CITY OF WACO

Date: 09/25/2020
RFB No: 2020-051
Commodity: Street Improvements – 2019 Reclamation Phase 1
Purchasing Agent: Mr. Kasey Gamblin

Addendum No: 2
Questions and Answers
Changes to Specifications and Drawings
Updated Bid Form

2019 Street Preservation Phase 1 – Contractor Questions (Addendum No.2)

Project No: 18ST2003C
Issue Date: AUGUST 2020
Sheet No: C801

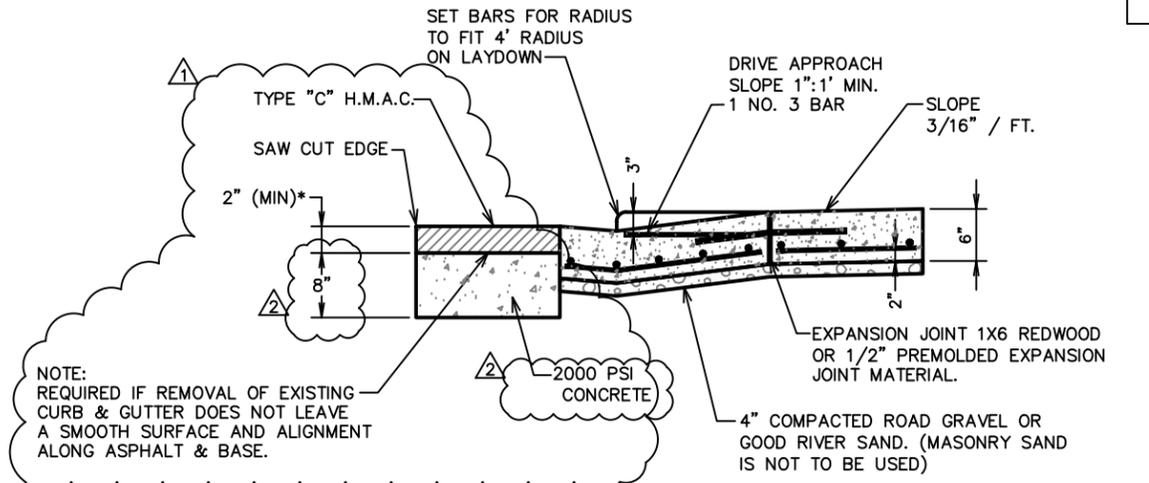
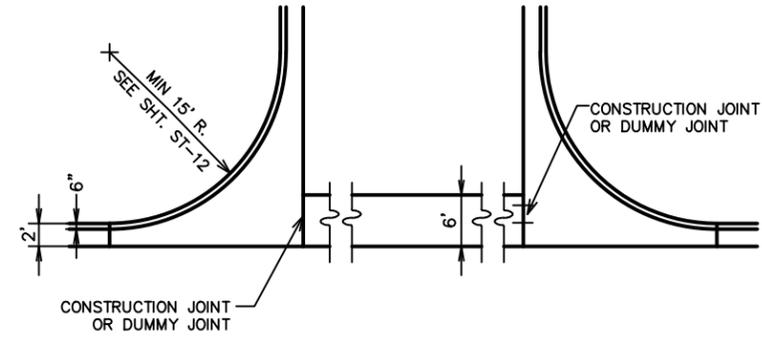
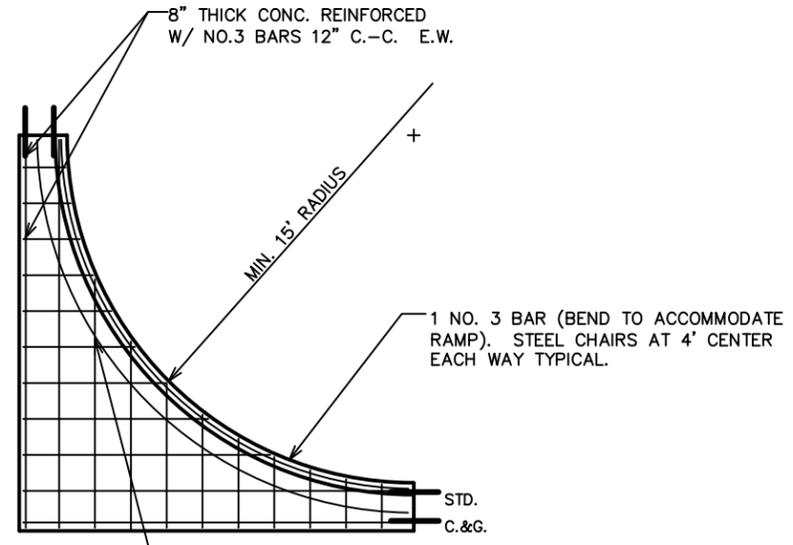
7. There are a few specific clearing notes shown for Cherry street. Is this the extent of the clearing?
8. What is the section composition for the 2' and 4' transitions?

8. The section shall be 2" of TYP C HMAC over 8" of 2000 psi concrete. Details on C801 and C802 have been revised.
9. Upon further investigation, the rail will not need to be painted. Sheets C005, C008, and C419 have been revised.

Project No:	Sheet No.
18ST2003C	C802
Issue Date:	
AUGUST 2020

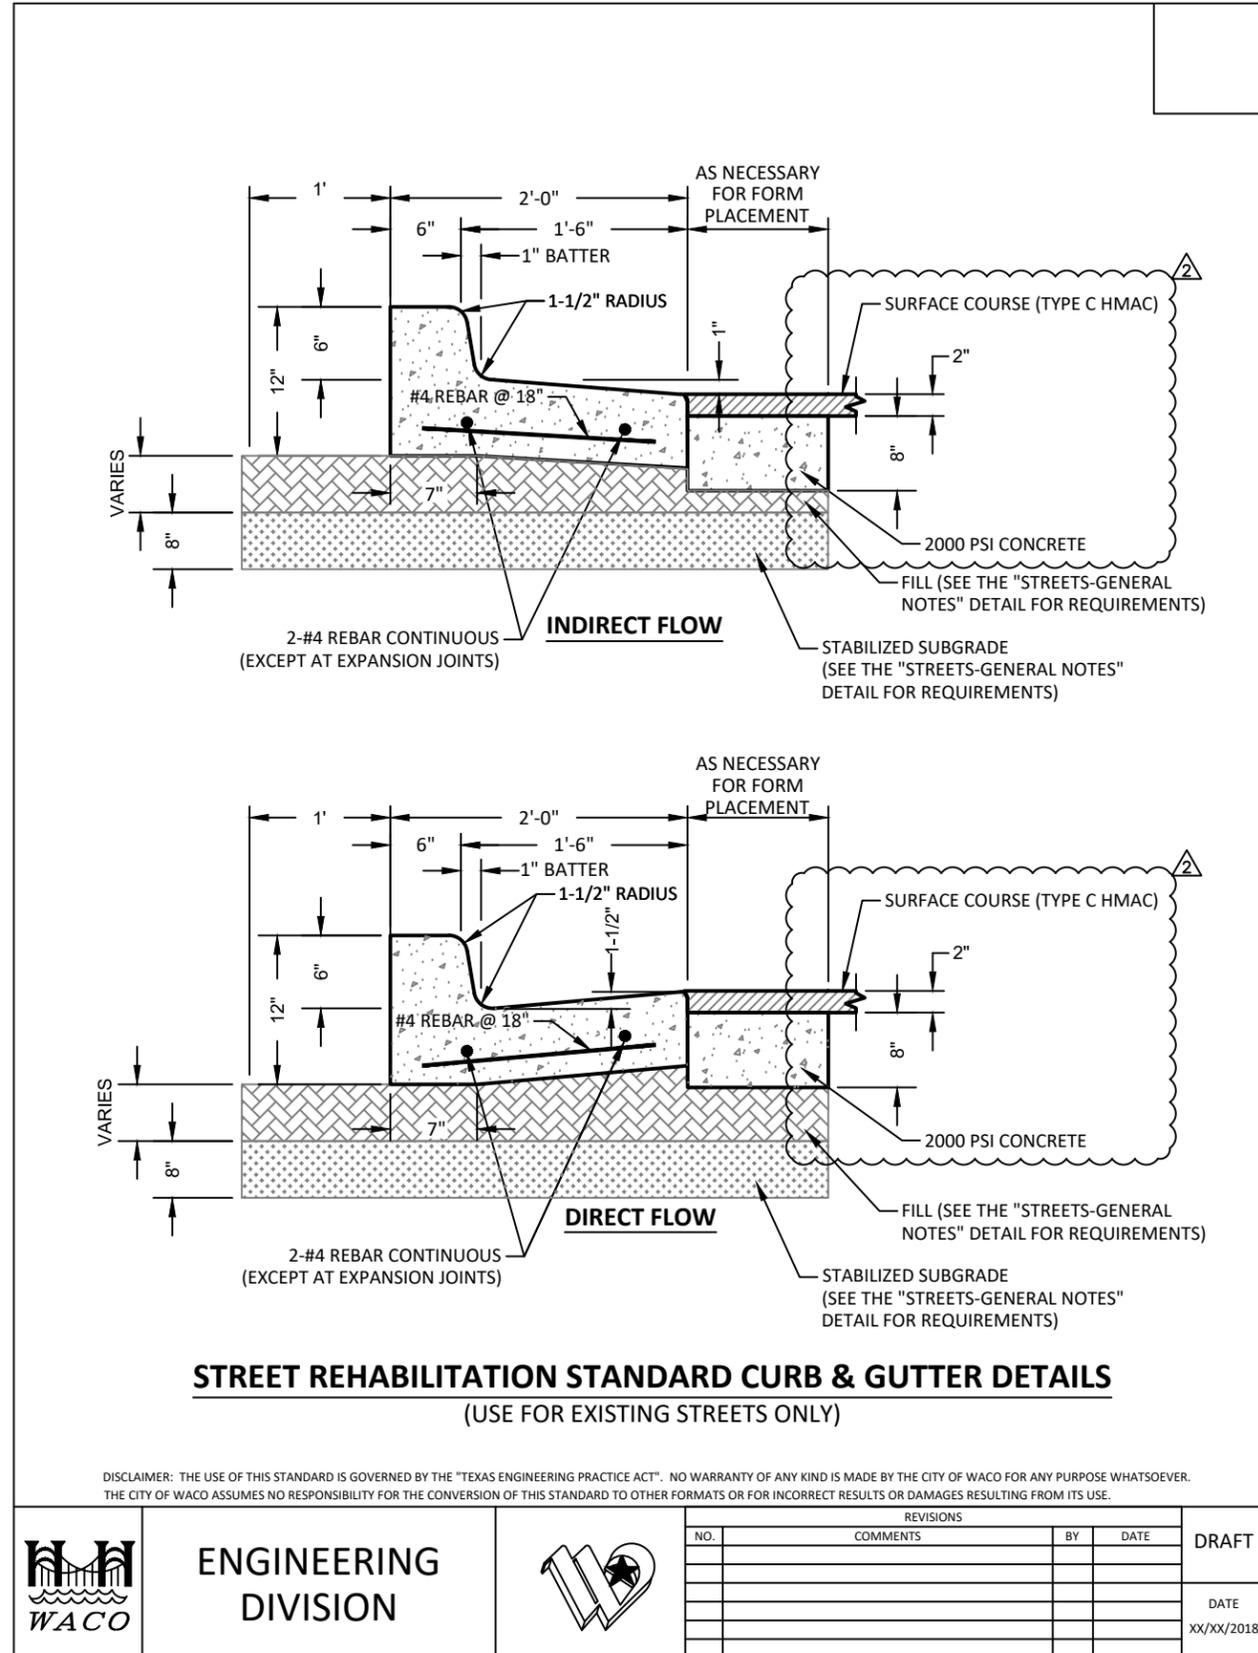
4. Please clarify what type of material is called out as Type B on the curb & Gutter Detail shown on Sheet C802. Is it Class B Concrete or Type B HMA? Historically it has been Class B concrete.

4. The material called out as Type B shall be revised to say "2000 PSI CONCRETE." Details on C802 have been revised. Note that the 2000 psi concrete shall only be used for pavement transitions between new curb & gutter and existing pavement. Reference the Typical Street Sections on C418 for new curb & gutter in areas to be reclaimed.
